Grand Teton National Park

Moose-Wilson Corridor Road Safety Audit

Conducted September 9-11, 2013

February 13, 2014

Figure 21. Standard Yellow Sheeting vs. Fluorescent Yellow Sheeting

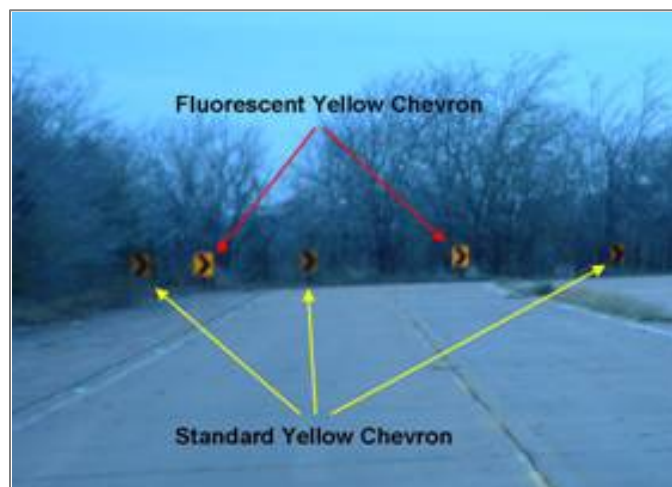
Develop an assessment or management method for addressing sign retroreflectivity, and create a sign replacement plan. The MUTCD has requirements regarding minimum retroreflectivity levels for warning and regulatory signs. These regulations require that all road agencies (including National Parks) have a plan in place by June 13, 2014, for how retroreflectivity standards will be met. The MUTCD regulations do not require that all signs be in compliance with the standard by this date, only that a plan to address compliance be in place. A good practice is to have a sign replacement plan that would address the retroreflectivity compliance dates in addition to covering how other signs are replaced or upgraded.

When replacing signs according to a sign replacement plan, the retroreflectivity of the sign should also be addressed so that the signs are visible at night and in low light conditions. Since the Moose-Wilson Road runs through some forested areas with heavy shadows, retroreflective fluorescent sheeting would improve the visibility of signs that provide

advance warning of curves, pedestrians, bicyclists, or the single-lane bridge.
